218786

**RESPONSE TO REQUEST FOR ADDITIONAL INFORMATION  
MARIST CATHOLIC COLLEGE NORTH SHORE REDEVELOPMENT SSD-10473**

5.0 CHILD CARE FACILITY

LEVEL 1 FLOOR PLAN - MAIN CHILD CARE FLOOR

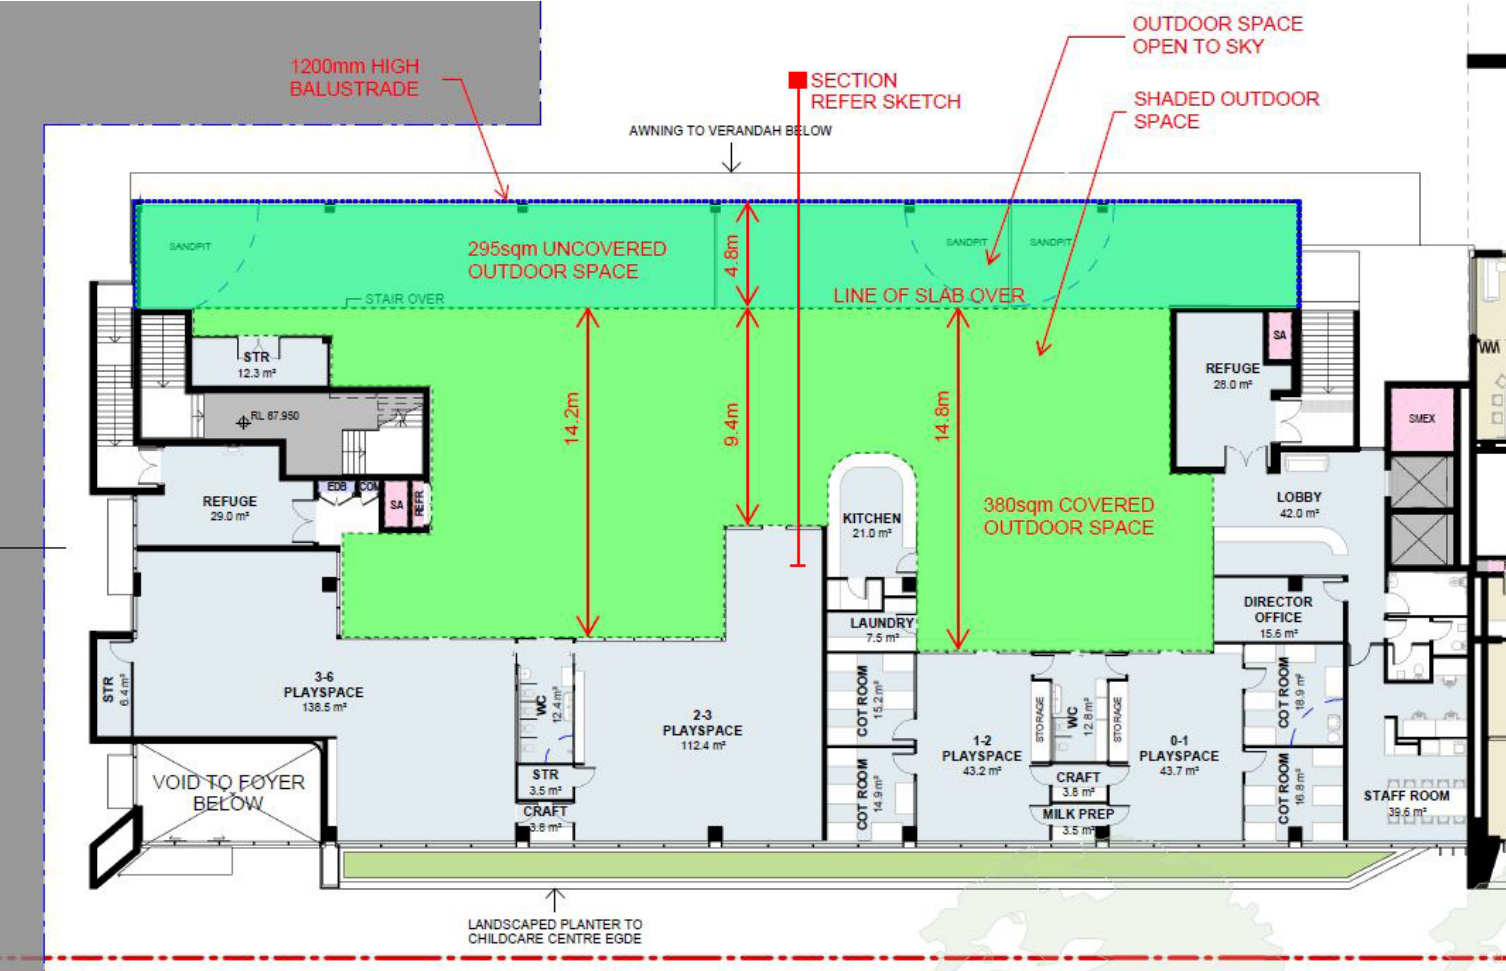
We write in response to the Department's letter dated 30 April 2021 requesting additional information in relation to the provision of unencumbered outdoor space for the proposed child care centre.

In response, WMK has updated the child care section of their design statement (a full update will be provided with the Response to Submissions) which demonstrates how the proposed open space complies with the requirements of the Child Care Planning Guideline. As shown in the **attached**, 40% of the outdoor area is open directly to the sky. The remaining open space is covered by the floorplate above. This component of the outdoor space comprises a large verandah and has been designed in accordance with the Child Care Planning Guideline. This space can therefore contribute to the unencumbered outdoor space area for the proposed child care centre. Therefore, concurrence from the Department of Education is not required and a redesign is not necessary.

Consistency with the criteria for a verandah, taken from Section 4.9 of the Child Care Planning Guideline, is outlined in the table below.

Criteria for Verandah as Outdoor Space	Proposal	Compliance
Be open on at least one third of its perimeter	An opening of 33.4% is provided	Yes
Have a clear height of 2.1m	A clear height of 3m is provided	Yes
Have a wall height of less than 1.4m where a wall with an opening forms the perimeter	The space is enclosed by a balustrade with a height of 1.2m	Yes
Have adequate flooring and roofing	Concrete structural floors are provided below and above, with a variety of warm floor and ceiling finishes and lining to columns.	Yes
Be designed to provide adequate protection from the elements	The verandah is protected by the building floor above and walls to the side and rear.	Yes

The childcare design locates the outdoor play areas to the western half of the floor plan where it benefits from long hours of daylight and naturally ventilated. The location within the floor plate provides the required shading to outdoor spaces through a verandah arrangement. 40% of the outdoor space is open directly to the sky, the remaining outdoor space covered by the floor above. The outdoor play area is a large verandah space designed in accordance with the NSW childcare planning guidelines, as demonstrated by the checklist below:

Criteria for Verandah as outdoor space	Proposed	Compliance
Be open on at least one third of its perimeter	Perimeter of Verandah = 140.6m Length of opening = 47m Opening = 33.4%	Yes
Have a clear height of 2.1m	Clear height provided = 3m	Yes
Have a wall height of less than 1.4 metres where a wall with an opening forms the perimeter	Balustrade height provided = 1.2m	Yes
Have adequate flooring and roofing	Concrete structural floors below and above, with variation of warm floor and ceiling finishes, and lining to columns.	Yes
Be designed to provide adequate protection from the elements	Verandah protected by the building floor above and walls to side and rear. Flooring below will be raised over structural concrete floor with integrated concealed drainage.	Yes
